Metropolitan Historic Zoning Commission  
Sunnyside in Sevier Park  
3000 Granny White Pike  
Nashville, Tennessee 37204  
Telephone: (615) 862-7970  
Fax: (615) 862-7974

## STAFF RECOMMENDATION 600 Monroe Street July 21, 2021

**Application:** New Construction—Addition; Partial Demolition  
**District:** Germantown Historic Preservation Zoning Overlay  
**Council District:** 19  
**Map and Parcel Number:** 08209003800  
**Zoning:** MUN  
**Applicant:** Tarl LaRocco  
**Project Lead:** Melissa Sajid, [melissa.sajid@nashville.gov](mailto:melissa.sajid@nashville.gov)

Figure 3. Left-side elevation.

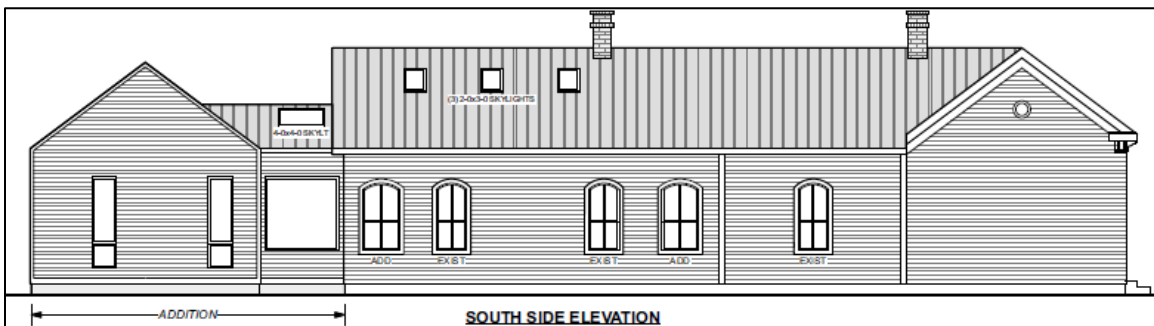
The application also proposes adding two windows to the left-side façade of the historic house to allow for egress (Figure 3). The proposed windows are located at or beyond the midpoint of the existing house, which is consistent with Section II.C.3.a of the design guidelines. In addition, the new openings are located on a non-street facing façade so are not likely to be visible from the street. The design of the windows is similar to the existing windows with the same overall height and sill height but wider to meet egress requirements. Staff finds that the addition of these two windows can meet the design guidelines.

Figure 6. Proposed right elevation.

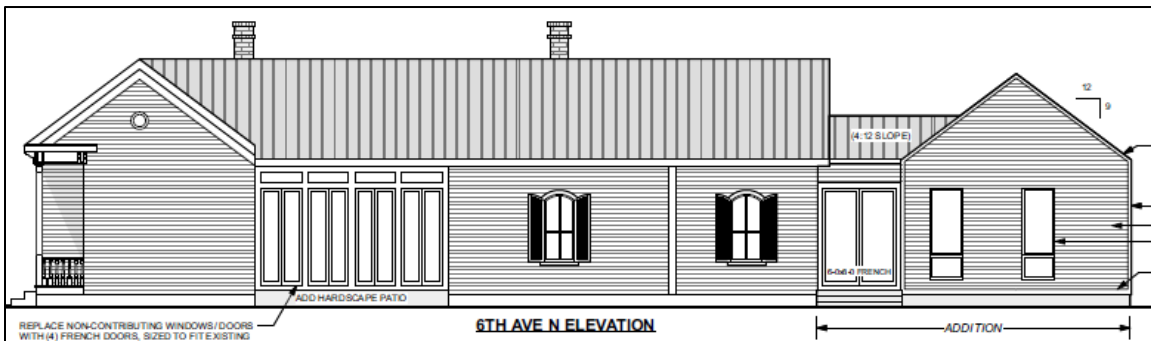
The application also includes replacing the existing windows of the enclosed porch on the right-side façade (Figure 4). The 1914 Sanborn map shows that the enclosed porch was previously a covered porch (Figure 5). Since the existing windows are not original as the porch was later enclosed, staff finds that replacing the existing windows can be

appropriate. The proposed replacement materials are full-light French doors which would increase the appearance of openness of the enclosed porch (Figure 6). With the condition that staff approve the final selections of the doors, staff finds that replacing the existing windows can meet the design guidelines.

1. Staff shall approve the final selections of the trim, windows, doors, foundation material, and patio material for the addition prior to purchase and installation;
2. Staff shall approve all permanent landscape features, included but not limited to fences, pathways, pavers, parking pads, pools, etc.; and
3. The HVAC shall be located behind the house or on either side, beyond the midpoint of the house, and utility meters shall be located on the side of the building, within 5' of the front corner or on the rear or rear-side within 5' of the rear corner. Alternative mechanical and utility locations must be approved prior to an administrative sign-off on building permit(s).

**6TH AVE N ELEVATION**

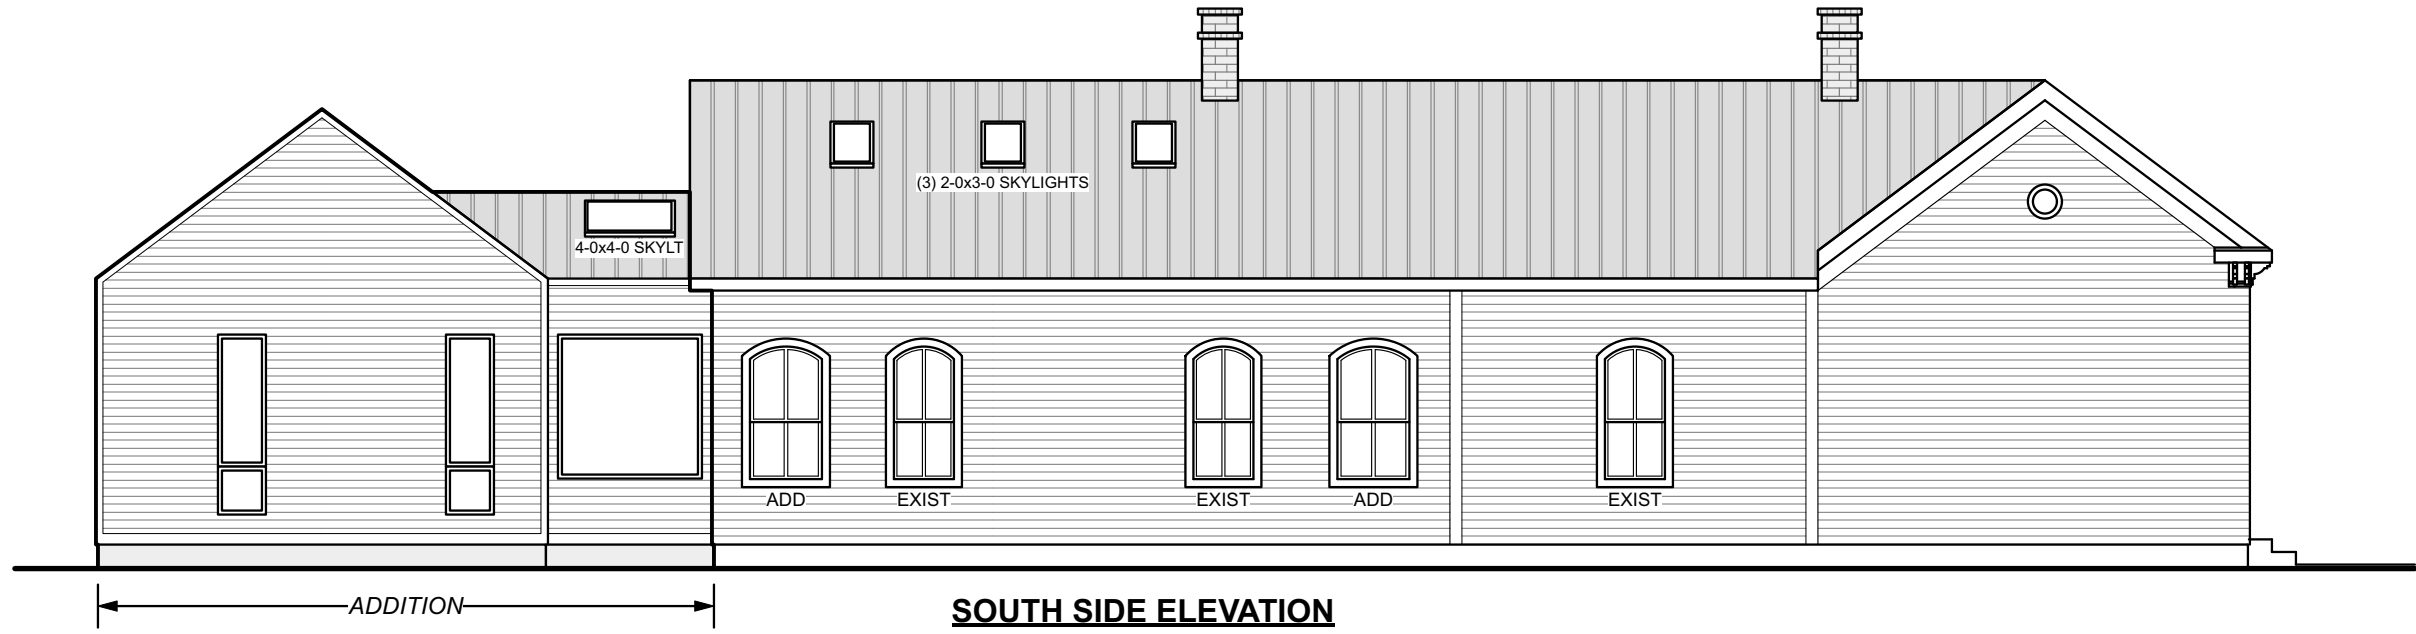
**Massing, Height, and Scale.** The proposed rear addition is one-story with eave and foundation heights to match the historic house. The addition ties in approximately four feet, six inches (4'-6") lower than the ridge of the historic house and is no taller or wider than the historic house at any point. The addition adds a net footprint of approximately four hundred eighty square feet (480 sq. ft.), which does not more than double the existing footprint or depth of the historic house. As proposed, the addition would meet the criteria for administrative approval if it were not for the requested setback determination from the side property line along Sixth Avenue North.

Setbacks. The addition meets all base zoning setbacks for the MUN district except for the street setback from Sixth Avenue North. The proposed addition is located three feet (3') from the interior side property line and fifty-five feet, three inches (55'-3") from the rear property line. The applicant has requested a setback determination to reduce the street setback along Sixth Avenue North from twenty feet (20') to eight feet, two inches (8'-2"), which is the existing setback for the historic house. Staff finds that the proposed setback determination can be appropriate for several reasons. The new construction is a modestly scaled addition that is appropriate for the historic house and located no closer to the right-side property line than the historic house. The lot is approximately thirty-three feet (33') wide, so if an addition were to meet both the interior and street setback, the result would be an exceptionally narrow addition. For these reasons, staff recommends approval of the requested setback determination, finding that the proposed setback determination is appropriate in this case. Staff finds that the proposed setbacks meet Sections III.E.2. and V. of the design guidelines.
